Addendum

Reconstruction at
Mahopac High School
Mahopac Middle School
Mahopac Falls School
Bus Garage
New Pump House

BID Addendum No. 3 to Drawings and Project Manual

February 22, 2021

First Floor Power Plan

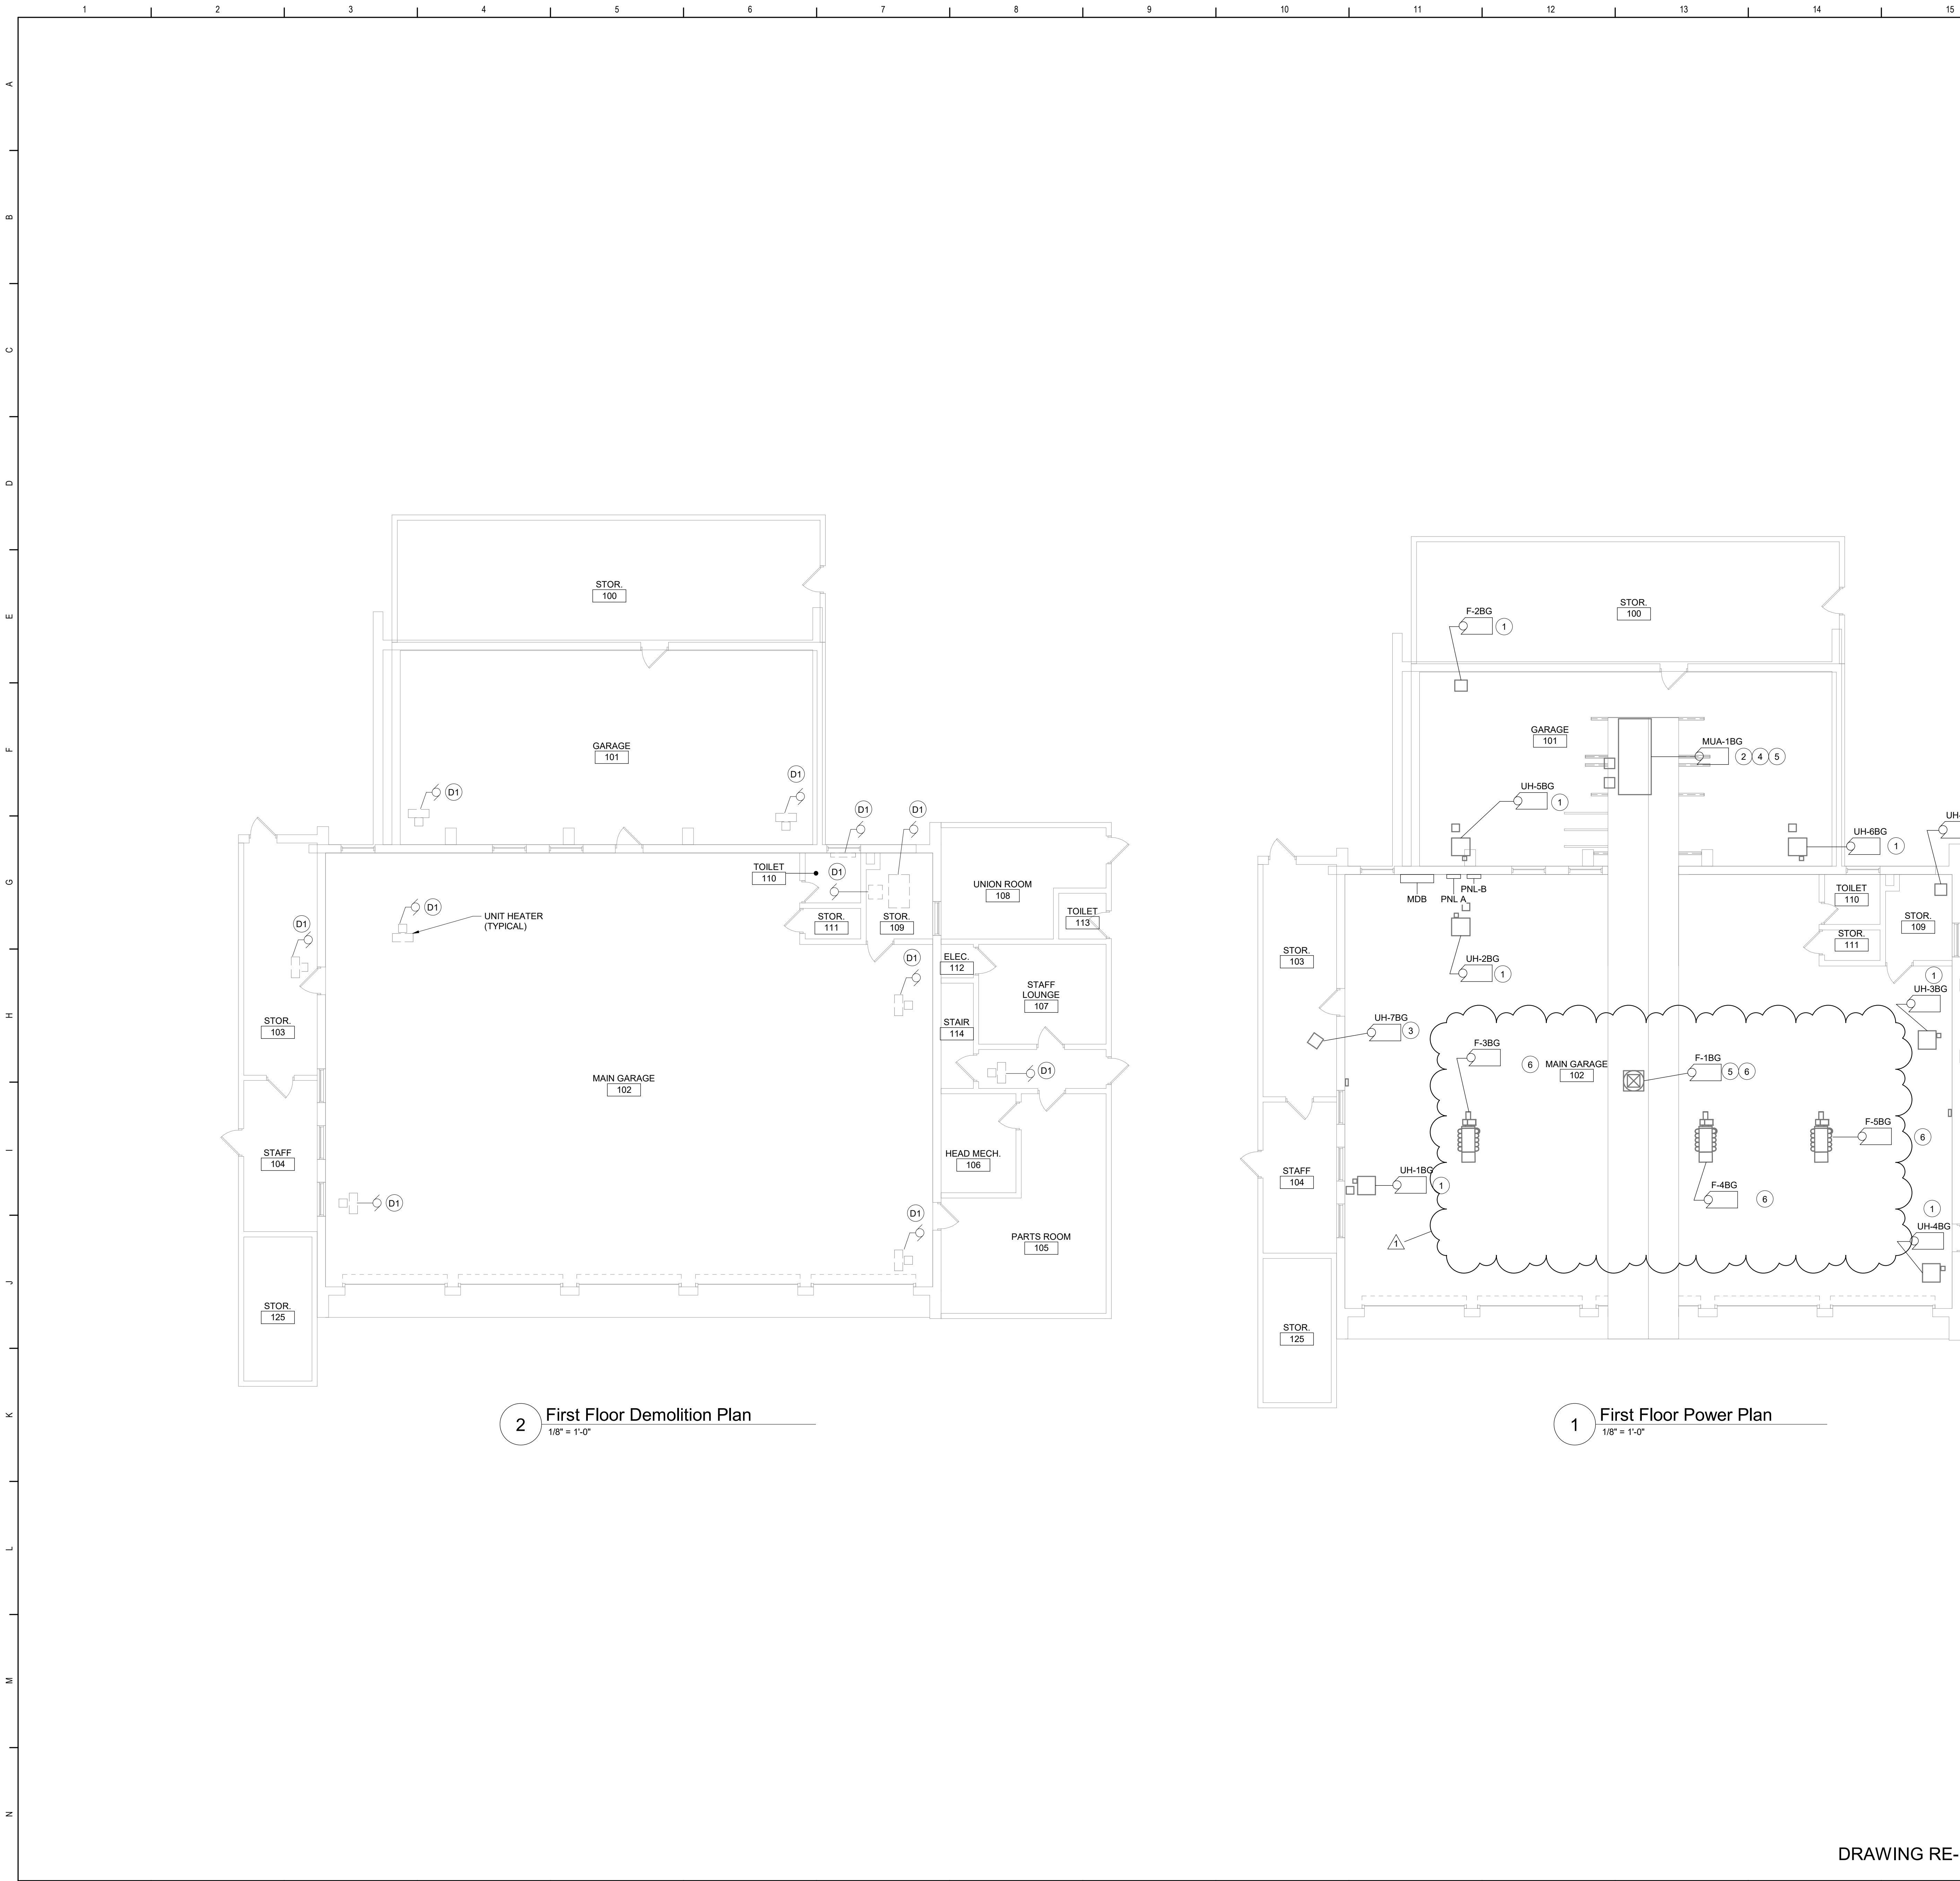
Question: (Please be specific) 1. confirm that disconnects per note 1 on this plan is the only scope of work here. It appears that when looking at Highschool drawing AE003 the feed to the pump house comes from the elementary school not the highschool, please confirm . AE700 also shows feed to pumphouse coming from the Highschool MDP, please provide correct drawing AE003 showing the route from the pumphouse to the highschool MDP location?
2. FE160 demo notes A-F mention demolition of lights, devices, disposl of lights with PCB. Can you provide plans that show lights to removed and which will need pcb removal? Or are these notes not part of the scope, please confirm scope of work at Elementary school?
